**CITY OF GRASS VALLEY
ENGINEERING DIVISION**

ADDENDUM NO. 1

**CDBG MEMORIAL PARK FACILITIES IMPROVEMENT
PROJECT, PROJECT NO. 20-05**

ADDENDUM NO. 1

SEAT RETAINING WALL

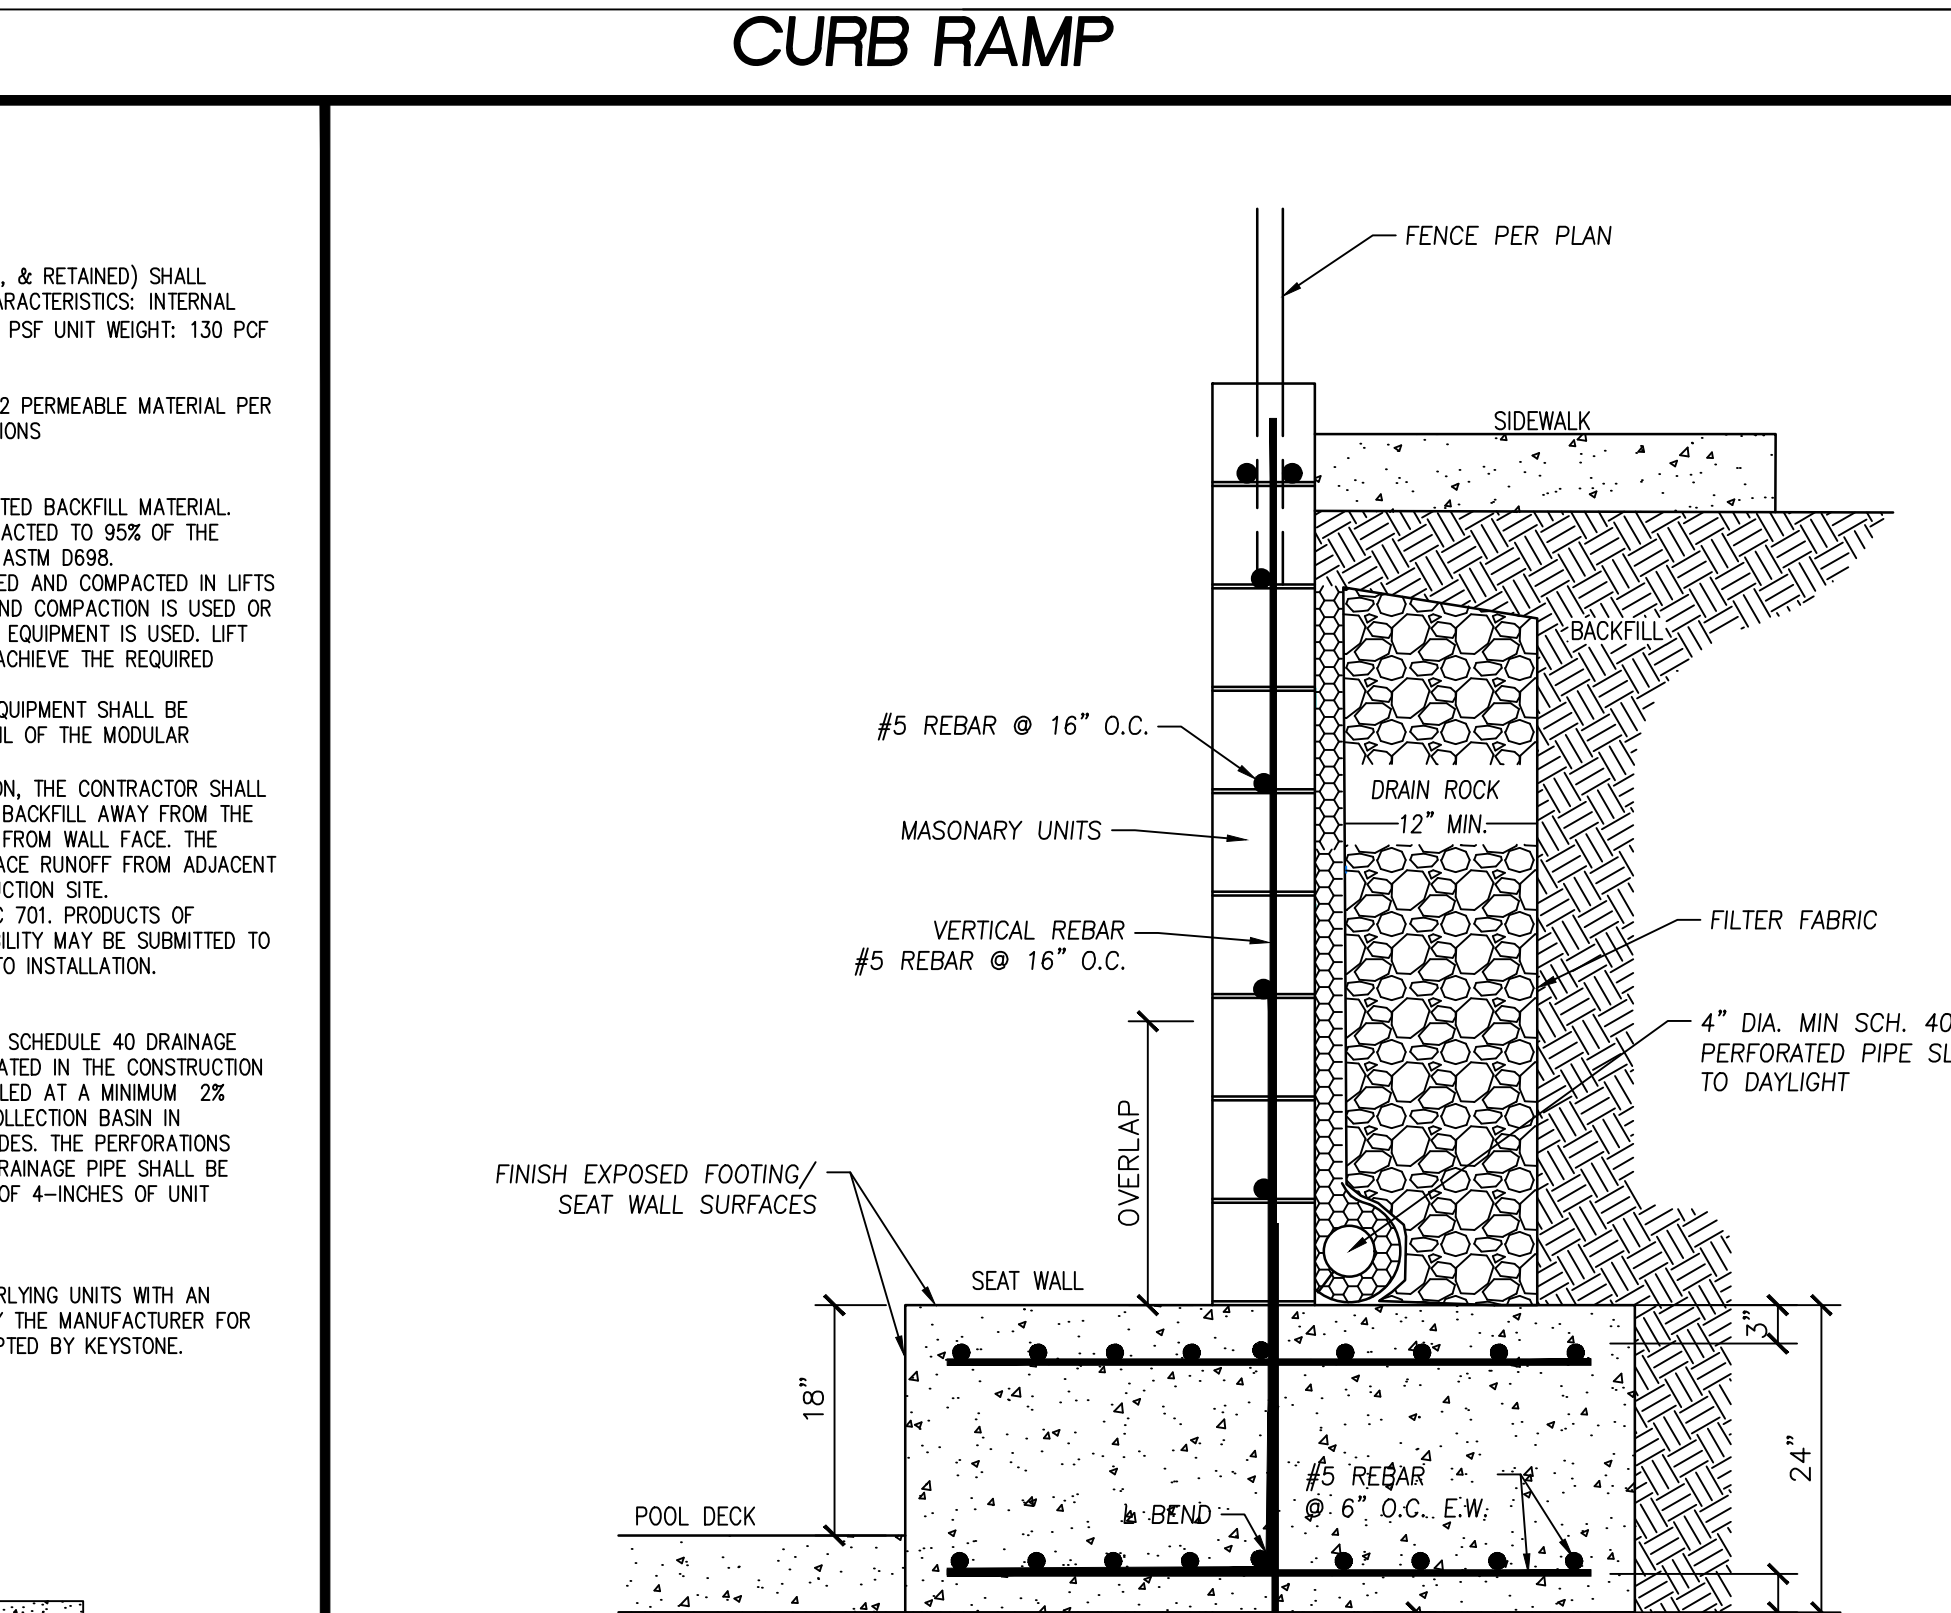
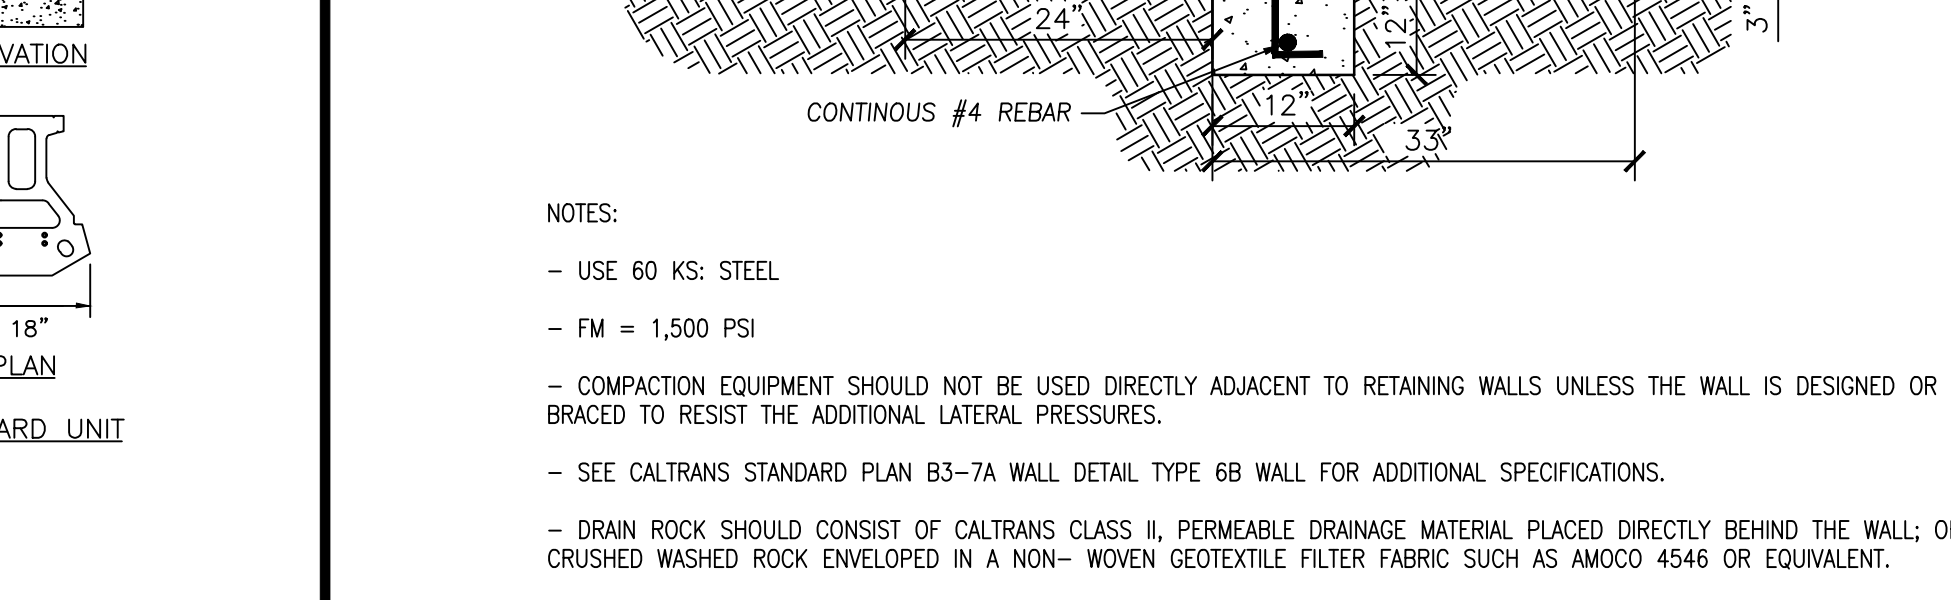
1. Sheet 1, Sheets 3 through Sheet 6, and Sheet 19. Replace the sheets in their entirety with the attached revised sheets. Remove reference to pool details. Modify the Activity Pool layout and cross sections. Move Seat Retaining Wall detail to sheet 19.
2. Sheets 7 through Sheet 9. Delete all pool details from the bid plan set.

No.	Description	Engr. Init	Date
1	ADD SEAT WALL DETAIL	BPJ	9/29/21
